ANNEXURES TO MEMORANDUM OF PLANNING MATTERS FOR AUCKLAND

COUNCIL - Project FTAA-2504-1055 ("Rangitoopuni Application")

Dated: 17 September 2025

Technical Specialist Memo - Policy Planning comments

Figure 2: Sight line for Access 2 towards the west, showing sight line over 417 Old North Road

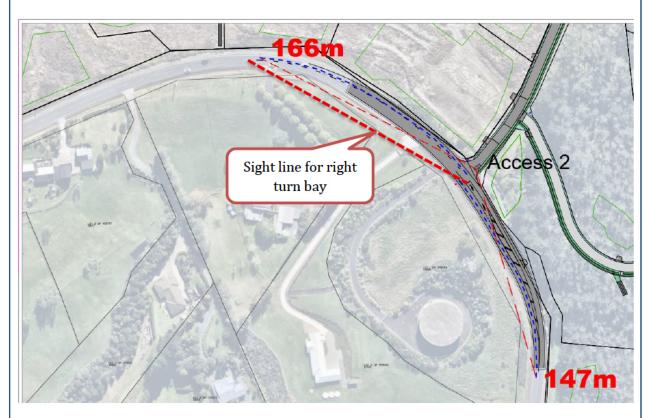
The western sightline for Access 2 crosses 417 Old North Road as shown in Commute Drawing SD A2, and my additional markups in the Figure below. This site is not owned by the applicant and therefore it is not able to apply land covenant over the property to ensure the sight line is protected. Further, as shown in Figure 3, the fencing for this property along with the horizontal and vertical alignment of Old North Road partially restricts the sight line. I am concerned about the potential safety effects due to:

In my opinion, these combined factors are point to an outcome that does not provide for safe access, contrary to Objective E27.2(4), and Policies E27.3(20) and (21).

To address the sight line shortfall, the exploration of relocating to the shared boundary between Lot 55 and Lot 57 is advised. I have shown the most efficient potential realignment of Browns Road to achieve this outcome in Figure 4, it is noted that this would require consideration of other effects of this change in layout. Access 3 could also be removed, as Lot 55 could gain access from the realigned Browns Road, however I acknowledge that Access 3 has sufficient sight lines in its proposed location and relocation of Access 3 is not necessary.

Figure 5: Potential alternative access to Lot 68 to remove sight distance infringement

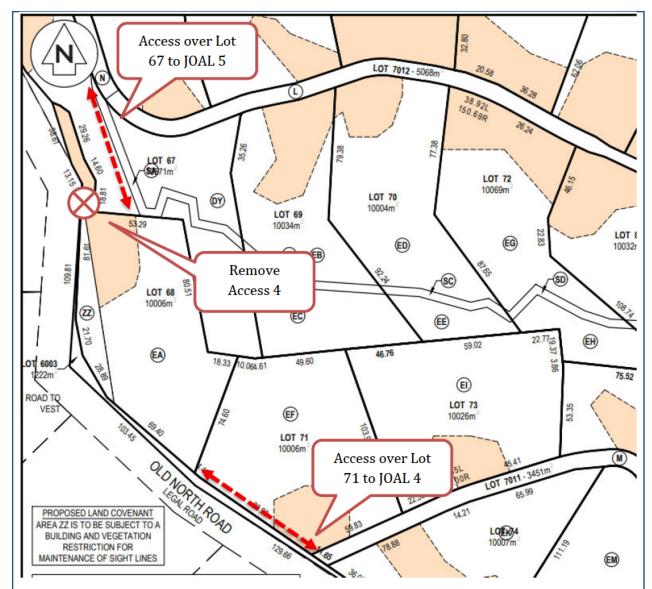
I am concerned about the western sightline for Access 4, which has a significant shortfall. This shortfall is more concerning when the longitudinal gradient of Old North Road is considered, as drivers on the western approach to Access 4 are travelling downhill and therefore will have require longer braking distances (181m and 231m respectively for cars and trucks, assuming a 6% downhill gradient and a 76 km/hr operating speed). Access 4 (servicing Lot 68) should not be approved, to do so will create unacceptable risk. I recommend that access to this Lot should be from JOAL 5 (e.g. with right of way over Lot 67, along the edge of the pedestrian right of way) or JOAL 4 (e.g. with right of way over Lot 71) as potential options to explore, having limited effects on the overall layout of the proposed subdivision from a transport engineering perspective, noting other considerations would need to be taken into account.

Figure 6: Mitigations for Access 5

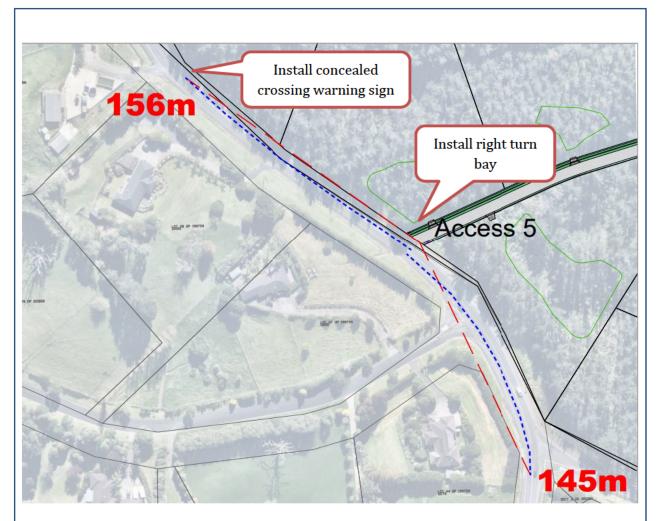
Similarly, the shortfall on the western approach to Access 5 is along a downhill gradient requiring 168m and 213m respectively for cars and trucks, assuming a 6% downhill gradient and a 72 km/hr operating speed). Access 5 (JOAL 4) will serve 9 Lots, and therefore will generate a reasonable number of vehicle movements, particularly during peak hours. I have considered whether an alternative location for the access could improve increase the available sightline but have not identified any suitable location.

If the Expert Panel chooses to approve Access 5 in its current location, to address the sight line and ensure turning traffic does not conflict with through movements then I strongly recommend that a right turn bay is provided on Old North Road, per the design for Access 1 and Access 3, and that advanced warning signage alerting drivers to a concealed crossing is installed on the western approach, as indicated in Figure 6.

Figure 7: 8m truck tracking at JOAL 1 / JOAL 2 / Old North Road intersection

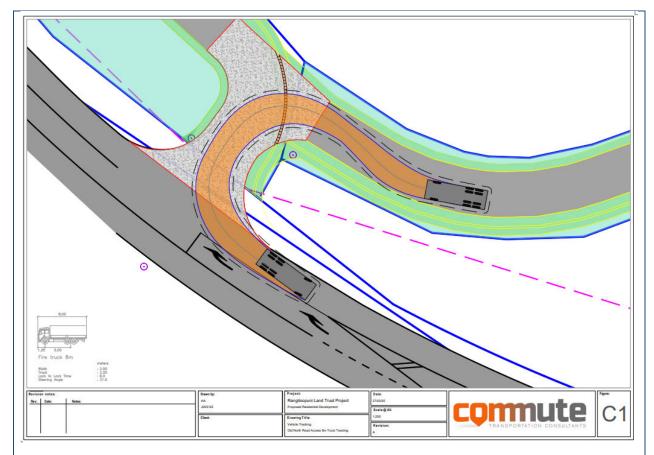
Regarding the JOAL 2 tie in with JOAL 1, I am not convinced by Commute's assessment of the potential for queuing off the site. I note that JOAL 1 serves 33 lots, and as such will operate similar to a low volume load public road in terms of traffic volumes. Auckland Transport's Urban and Rural Road design Guide Table 2 requires Local to Arterial Road intersections to accommodate an 8.3m truck to remain within the marked lane when tracking through the intersection. 8m truck tracking provided in the ITA, and reproduced in Figure 7 below, shows an outbound truck needing to occupy the full carriageway of JOAL 1 and JOAL 2. A truck driver undertaking this manoeuvre would not be able to see any car turning right from Old North Road into the site. Further, for an inbound truck movement, an outbound car would need to wait a significant distance within the site to allow the truck to pass. Compounding this matter is the potential for gates to be erected.

Figure 8: recommended amendments to Old North Road/Access 1

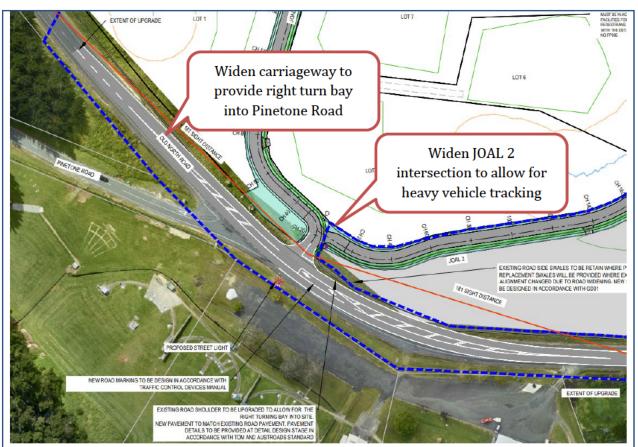
This will require deviation from the Scheme Plan as boundary adjustments will be required, as such confirming this redesign now is encouraged and at a minimum a condition of consent that highlights this requirement should be included.

I have shown these recommendations in Figure 8.

Figure 9: LOT 1 & 2: TRACK NETWORK, (Source: Rangitoopuni Masterplan)

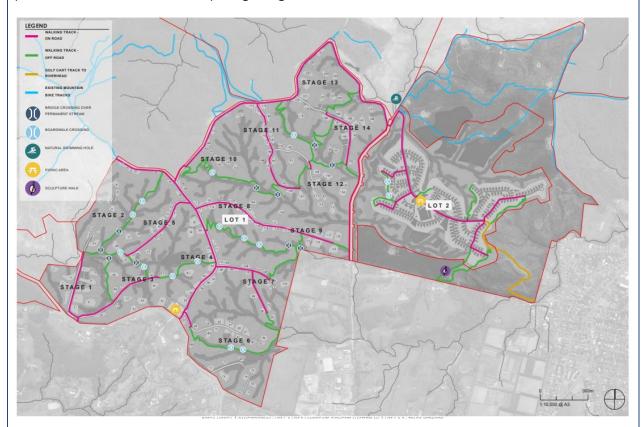
The Masterplan and Landscape Concept Plan shows multiple pedestrian paths through the site (refer to Figure 9), easements are shown on the Lot plans, although formation of the connections is not shown in the Engineering Drawings. If these connections are not provided this will significantly limit walking and cycling accessibility, resulting in increased car dependency.

I therefore recommend that, if the application is approved, a condition of consent is applied that requires the consent holder to form these paths to Council's satisfaction.

Furthermore, given the lack of footpath facilities within JOALs, I recommend that traffic calming is provided at not more than 50m spacing along all JOALs.

Figure 4 - Proposed Access 1 Layout with visibility splays highlighted

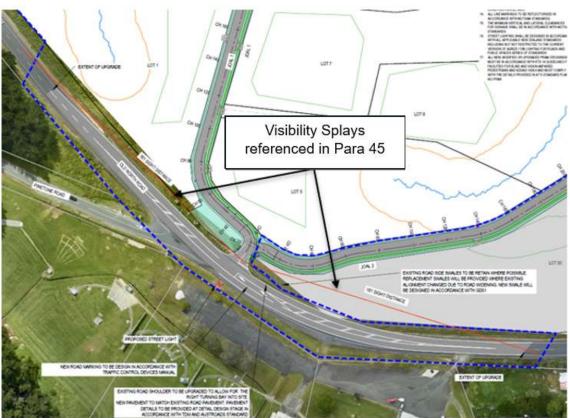
- 44. The existing site access on Old North Road will be upgraded with a right-turn bay and flush median. However, the design does not fully account for nearby Pinetone Road. It is recommended that right-turn movements to and from Pinetone Road be better integrated into the design. Final details can be resolved during the EA process, and sufficient land appears to be available for any required widening.
- 45. Visibility splays are generally acceptable, with a land covenant proposed to maintain sightlines to the east. To the west, vegetation and embankments may need to be removed or modified.

- 46. Vehicle tracking shows a 10.3m truck slightly encroaching into the right-turn bay, which will need to be addressed at the EPA stage. The access splits into two JOALs, and while queuing is expected to be minimal, the design should ensure vehicles can enter without being blocked by outbound queues.
- 47. Gates are proposed for both JOALs and will be set back at least 6m, forming a T-shaped turning head to allow vehicles to turn around safely if needed.
- 48. Access 1 is within 10m of Pinetone Road, triggering vehicle access restrictions under AUP Rules E27.6.4.1(2) and (3). While this requires assessment as a restricted discretionary activity, there are no existing safety concerns, visibility is adequate, and the access is not expected to impact the safe or efficient operation of the road network. Pinetone Road is a low-volume cul-de-sac.

Figure 6 - Deacon Road / Riverhead Road Intersection

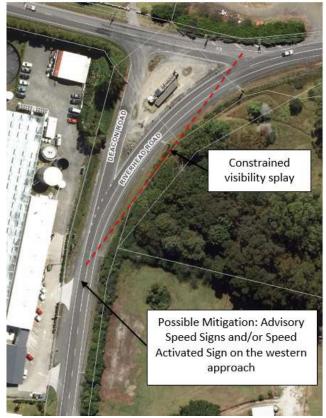
- 59. The ITA has reviewed the safety record of the Deacons Road / Riverhead Road intersection and identified a crash trend, particularly involving right-turning movements. Visibility from Deacons Road to the west is limited—only about 120m is available versus the 181m required for an 80 km/h design speed. This shortfall is likely contributing to the crash trend.
- 60. Although the proposed development does not directly affect visibility, it would triple the volume of right-turning traffic from Deacons Road during the AM peak, increasing crash risk exposure. Mitigation measures such as advisory speed signs or speed-activated warning signs on the western approach are recommended to improve safety (refer to Figure 6).

Figure 4 - Proposed Access 1 Layout with visibility splays highlighted

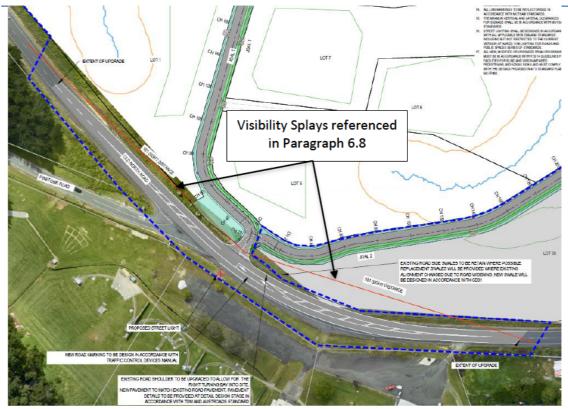
- 6.8 The visibility splays for the intersection extend over the berms either side of the access. The Scheme Plan drawings indicate that the land to the east of the vehicle crossing would be subject to a land covenant to maintain the sight lines east of the access. This is considered appropriate as vegetation may grow over time that could block the sight lines to the east. To the west of the vehicle crossing, there is a berm and embankment. It is considered that the bank and vegetation would need to be removed or modified to maintain the sight lines. This is highlighted in Figure 4.

- 6.9 The Scheme Plans show that some of the land along the site frontage either side of the vehicle crossing will be vested. The extent or form of any modifications for this land to create the vehicle access is not clear.

Figure 6 - Deacon Road / Riverhead Road Intersection

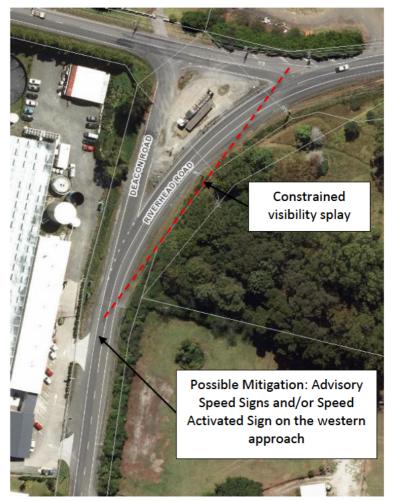
visibility at the intersection, it does triple the right turn volume from Deacon Road in the AM peak8 thereby increasing the crash risk exposure.

6.34 Mitigation measures may be appropriate, such as advisory speed signs or speed-activated warning signs on the western approach to the intersection (refer to Figure 6).

Figure 2 - Extent of known detail for 'culverts'. Not clear existing vs proposed vs replacements and total modification of stream bed.

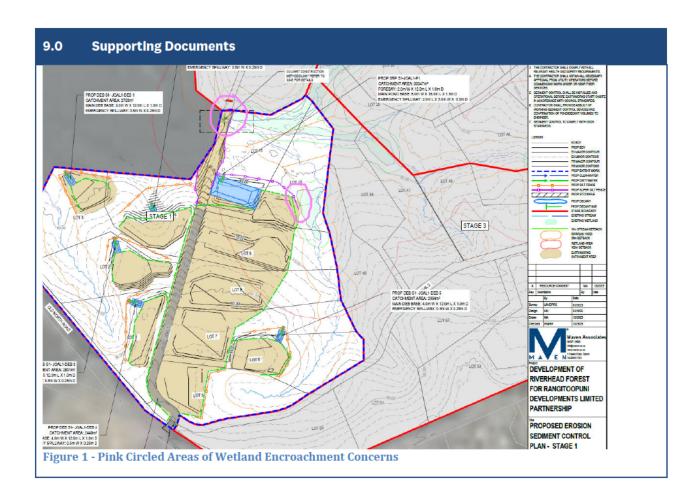
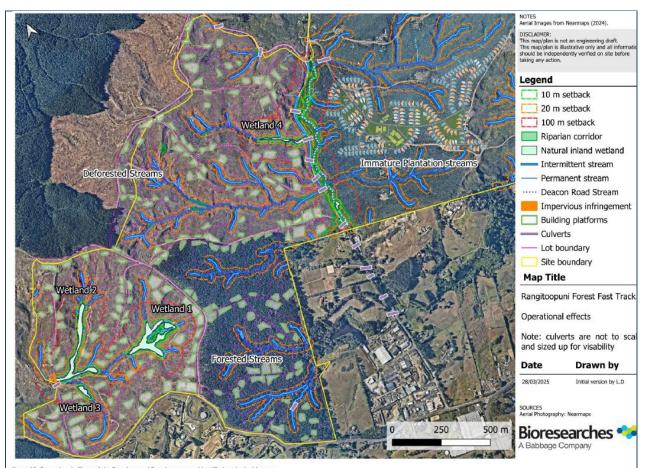
been referred to as Culverts 1-1 and 6 in the application documents and plans. The extent of the structures including stream bed modification has not been discussed within the ecological assessment in terms of any mitigation or overall level of effect. It is acknowledged that there is low flow culverts proposed adjacent to the structures which are said to provide for fish passage. However, it is unclear how these low flow culverts would operate if they were to sit 'beside' the structure located in the stream and whether the fish passage standards in E3 can be met per E3.6.1.14(3) 'The structure must not prevent the passage of fish upstream and downstream in waterbodies that contain fish, except that temporary restrictions to fish passage may occur to enable construction work to be carried out'. This cannot be deferred to conditions given it is a structural and functional element to ensure ecological outcomes. Risks of not having the information upfront includes structural elements – where fish passage retrofits may be physically impossible to include if the dam is built too high and potential ecological impacts including the blockage of native fish during critical migration periods.

- XX Fish passage must be maintained through the culvert structures in perpetuity, and monitoring, maintenance and remediation measures must be undertaken in accordance with the FPMMP through the lifetime of the structures.
- XX All rip rap must be embedded into the bed of the stream to ensure water flows over, rather than through, the rock to maintain fish passage. The installation of the rip rap must be overseen by a freshwater ecologist.
